TOWN OF KILL DEVIL HILLS

NOTICE OF PUBLIC MEETING

Subject: SITE PLAN REVIEW — 1106 Blue Jay Street — Proposed Professional Office Building (Dentist Office)

DRAWING TITLE: EXISTING CONDITIONS PLAN

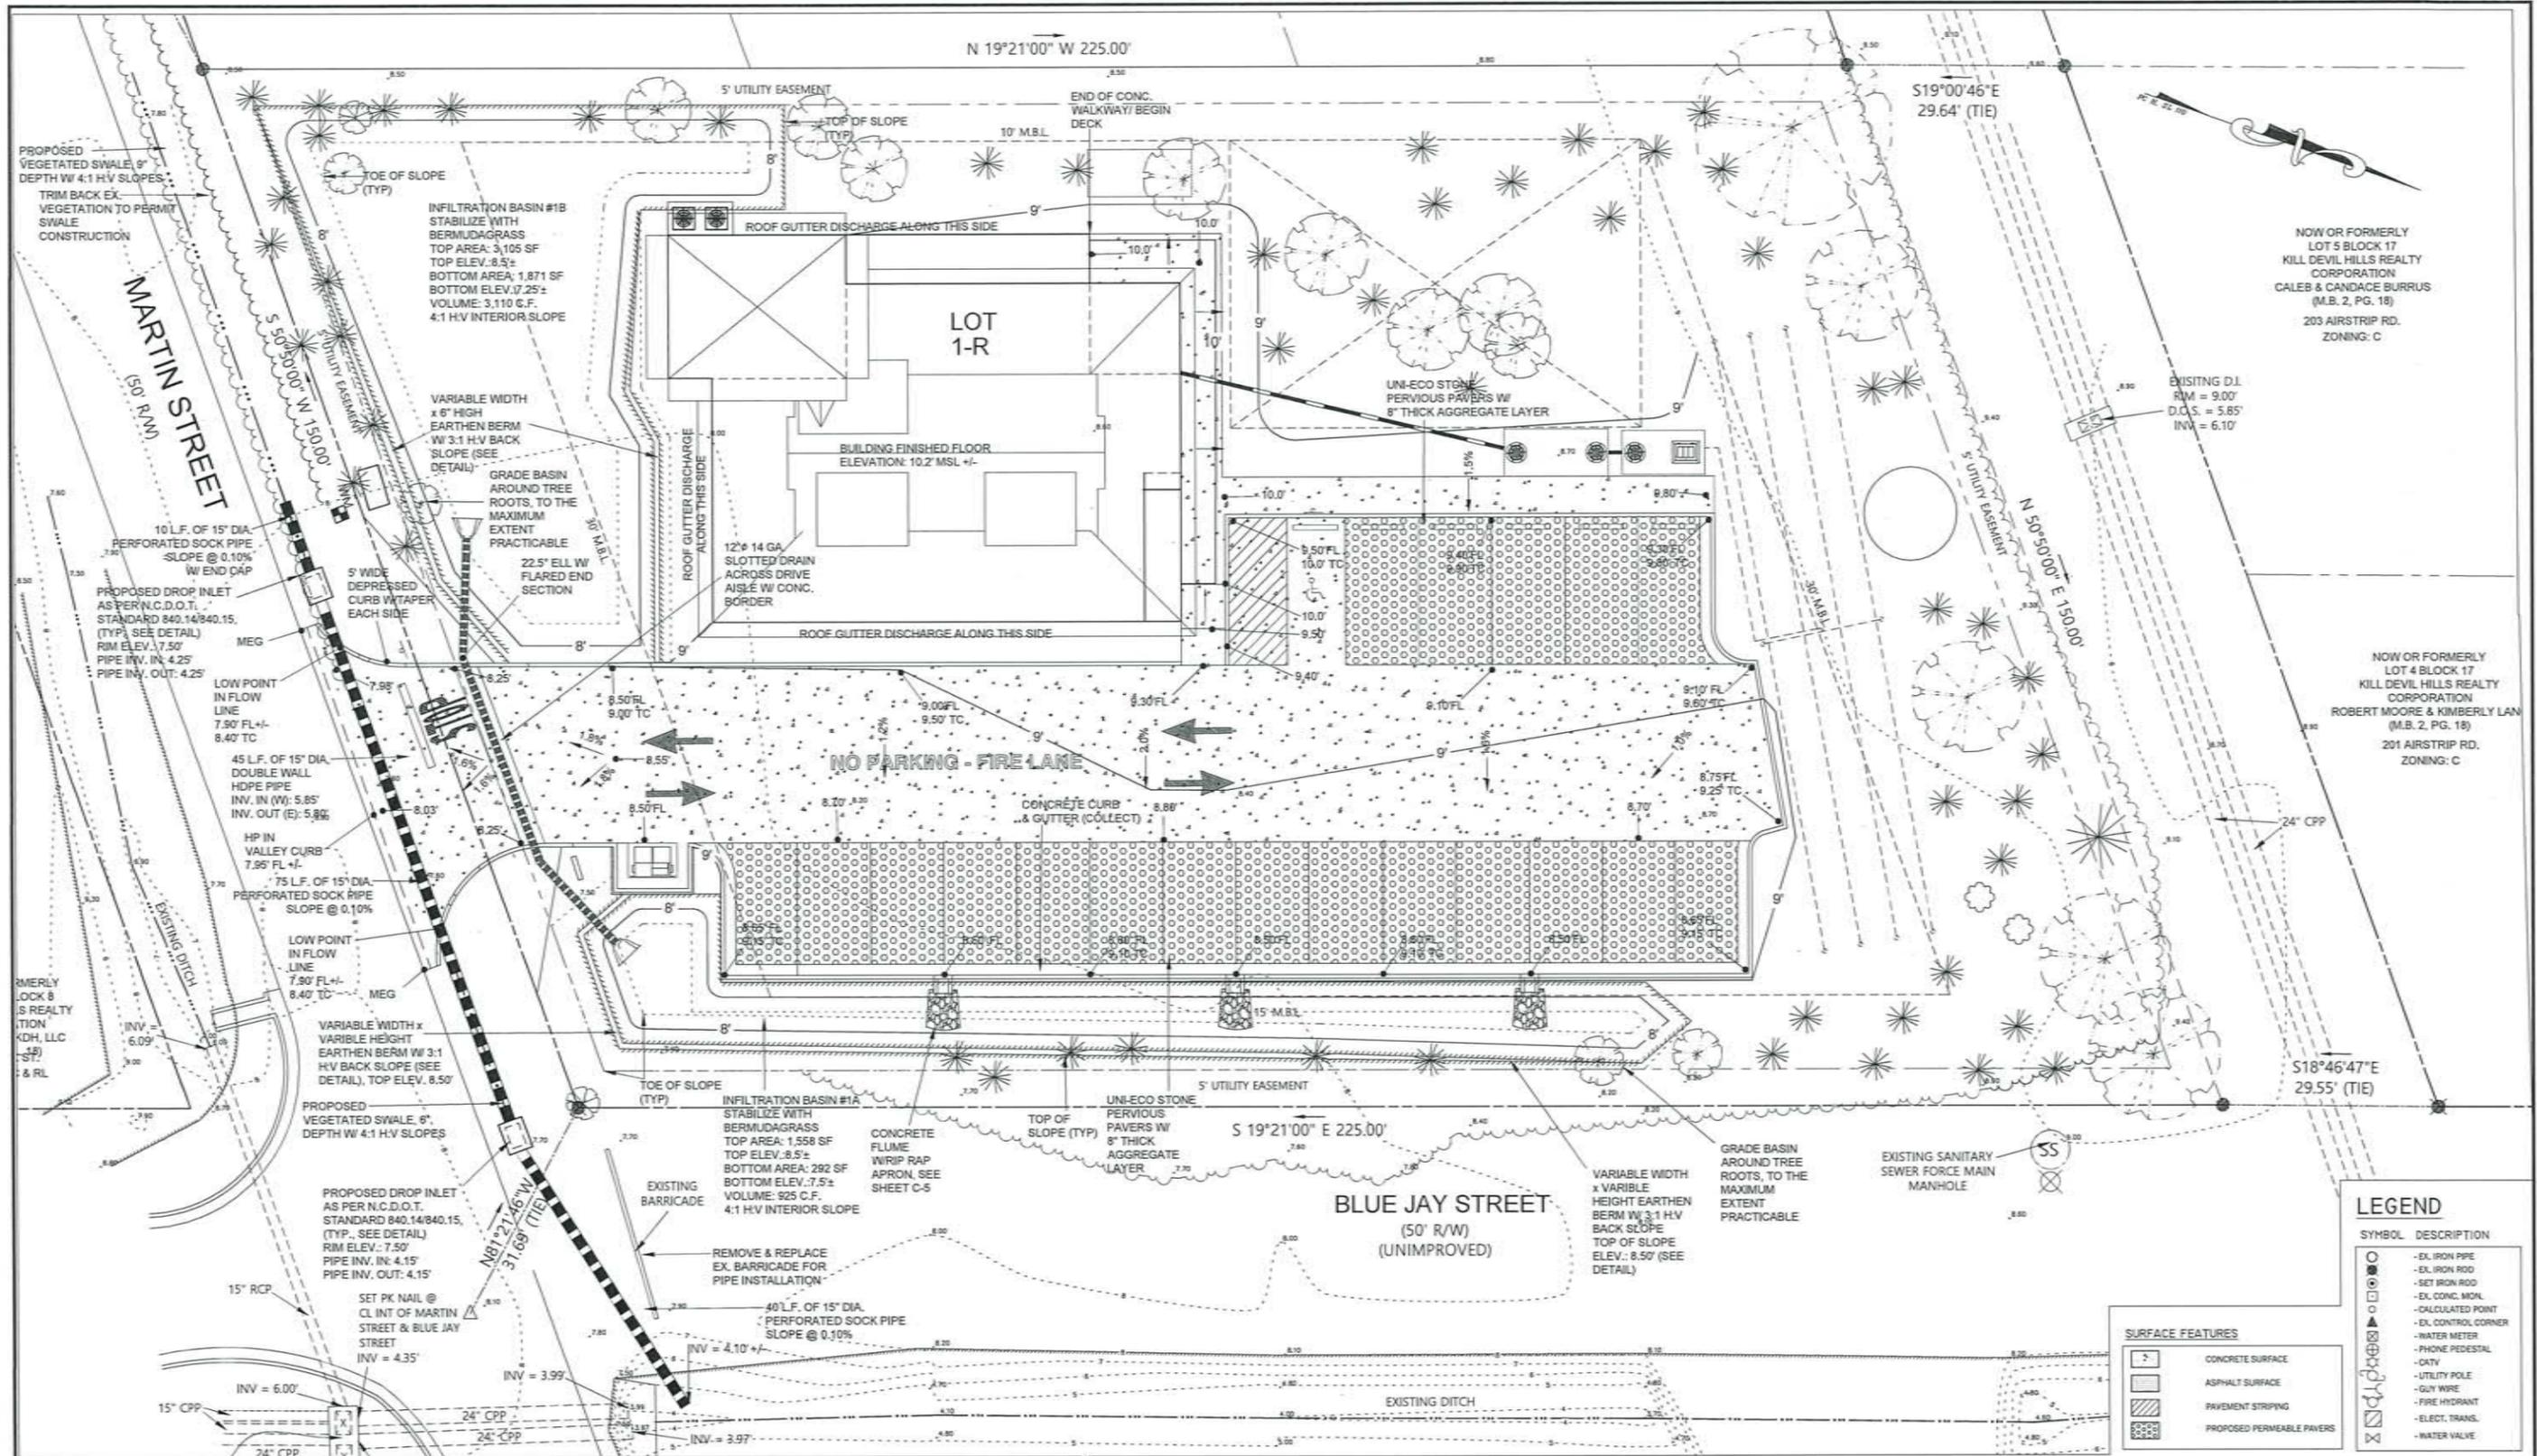
Sheet C1 Existing Conditions Plan:

1. A 20'x50' construction entrance is required. *Answer: A 20'x50' construction entrance is provided on sheet C-1*
2. Add to Erosion Control Sequence: "Obtain all necessary Federal, State, or Town of Kill Devil Hills permits prior to land disturbance". *Answer: This note has been provided prior to the construction sequence schedule.*

DRAWING TITLE: **GRADING AND DRAINAGE PLAN**

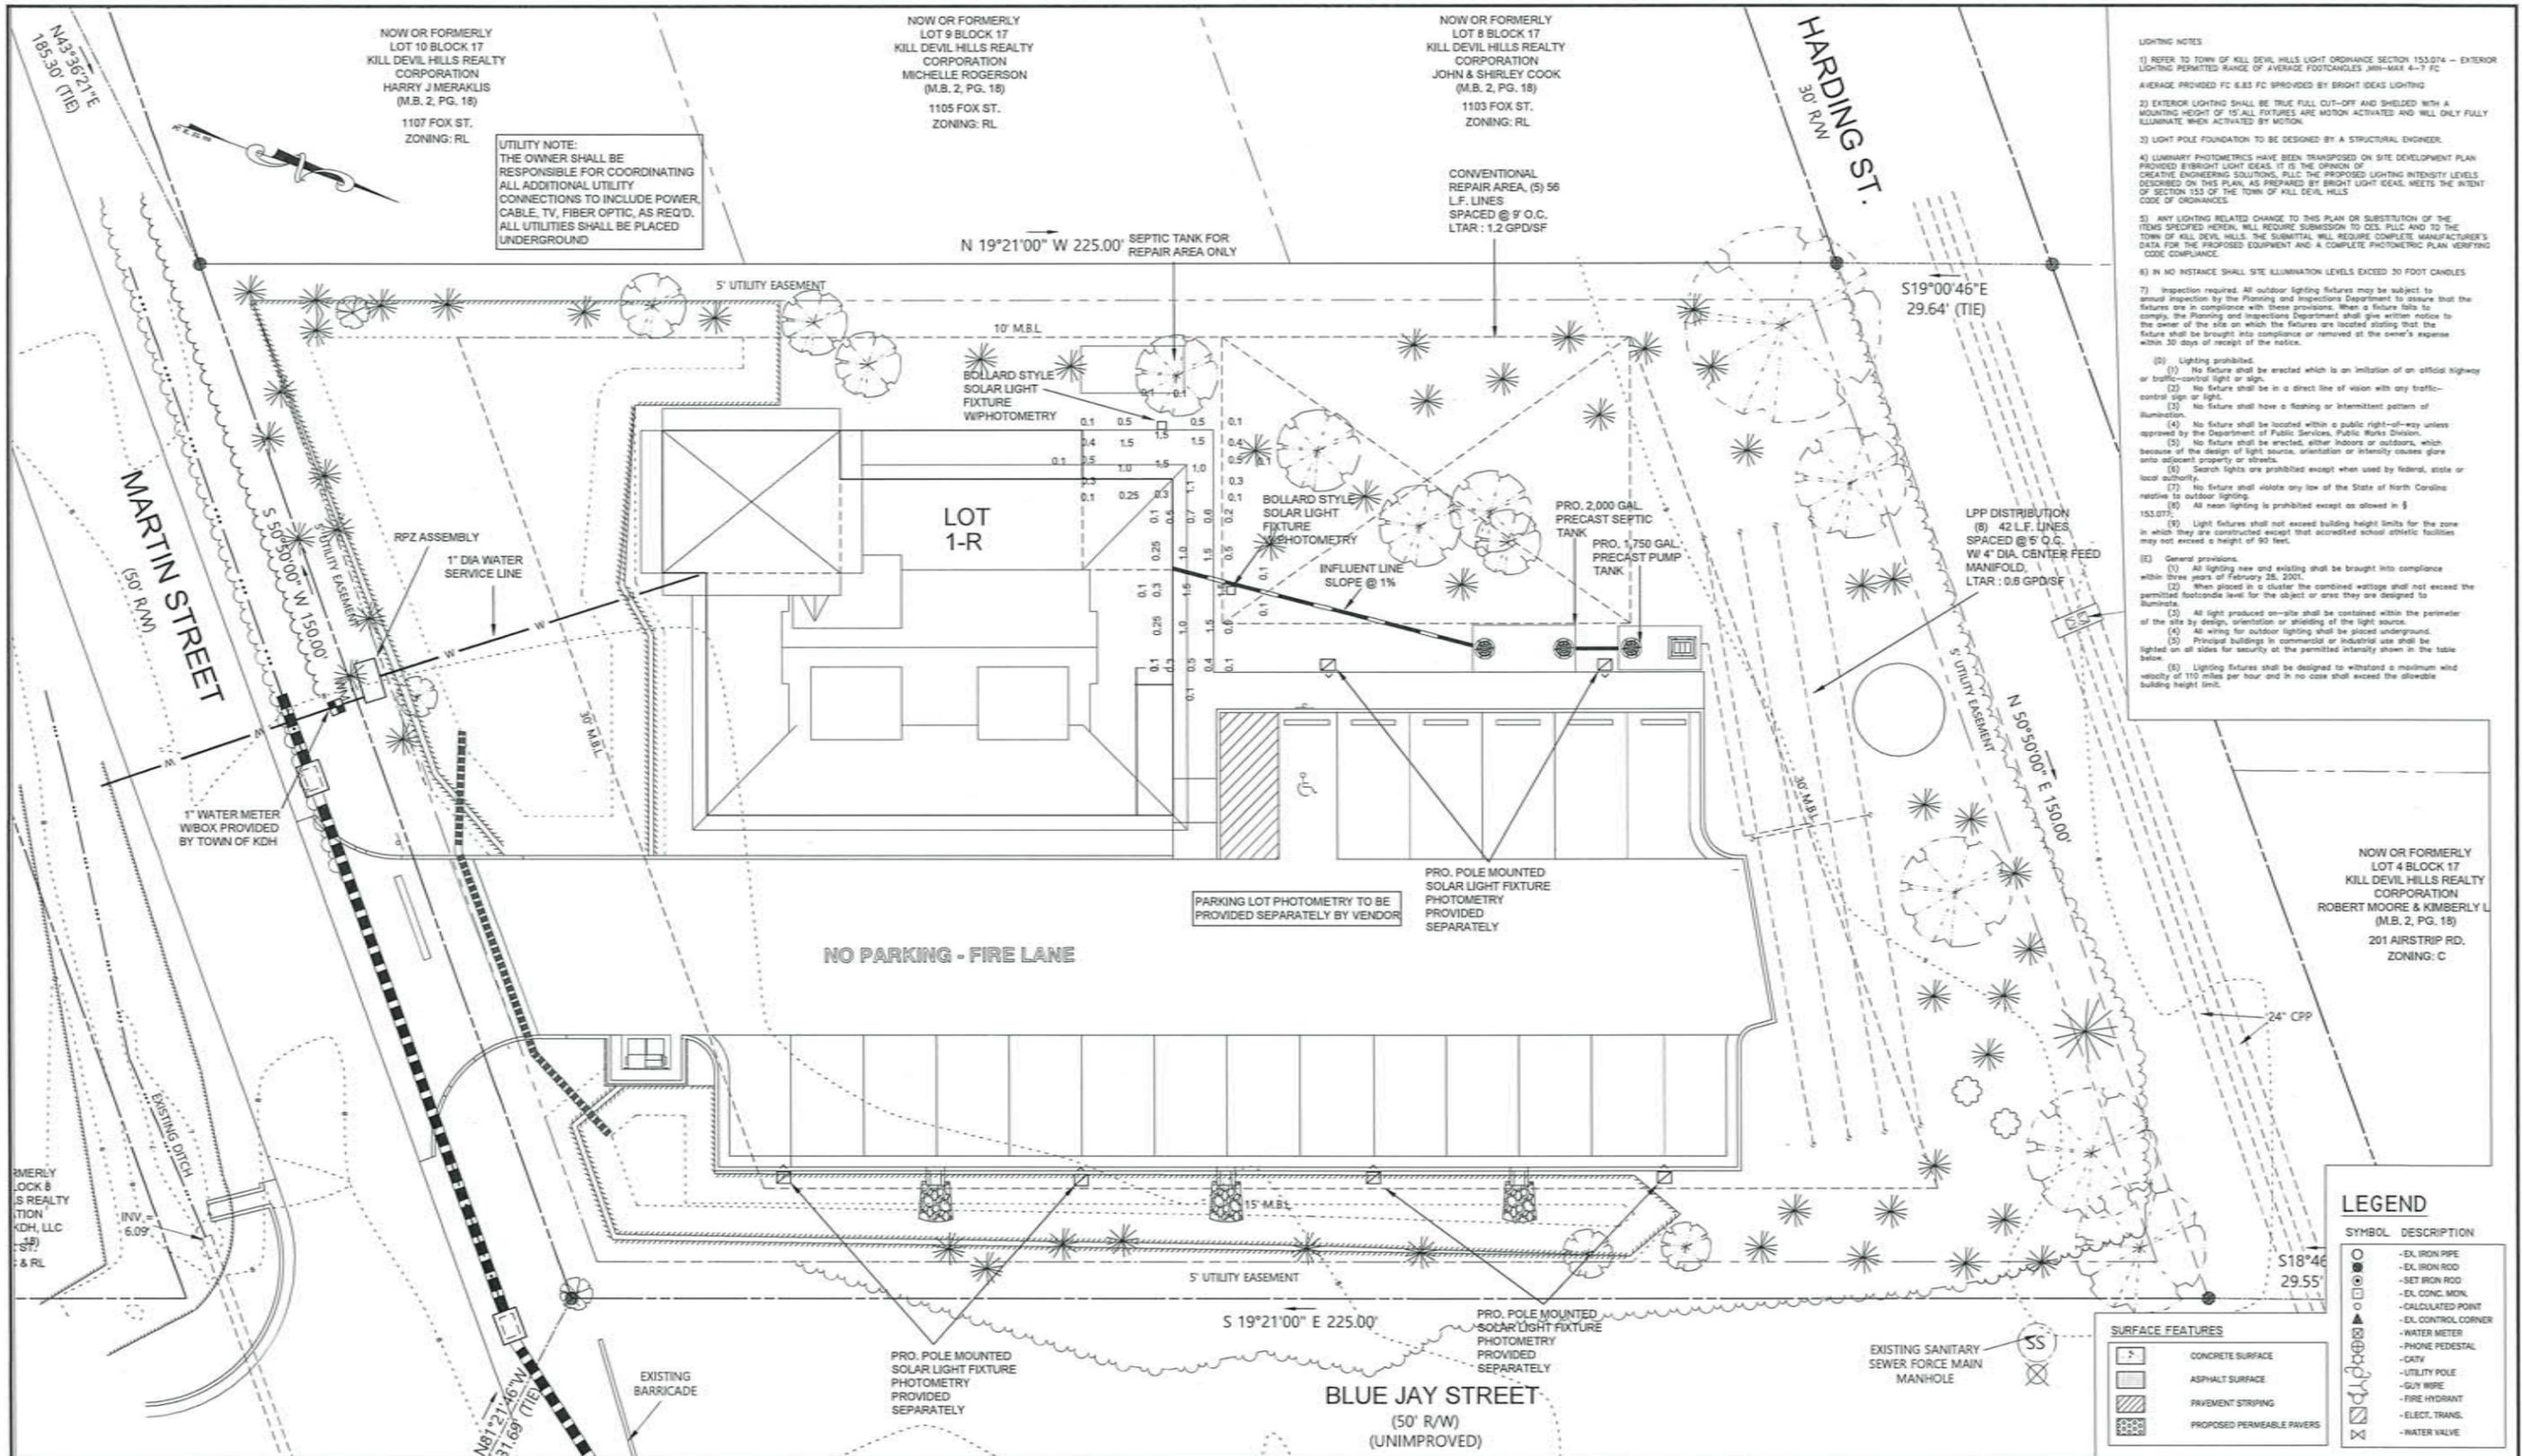
Sheet C-3 Grading and Drainage Plan:

1. Provide grading details for entire site including elevations of proposed sidewalk around rear of building and with retaining wall. Answer: Final grading spot elevations and finish grade contours are provided. A retaining wall is not required. Please reference the architectural west side building elevation.
2. Identify stormwater management features. Answer: Stormwater Management Control Measures are accurately depicted and notated.
3. Provide detail for riprap outlet protection. Answer: This detail information is provided on Detail Sheet C6
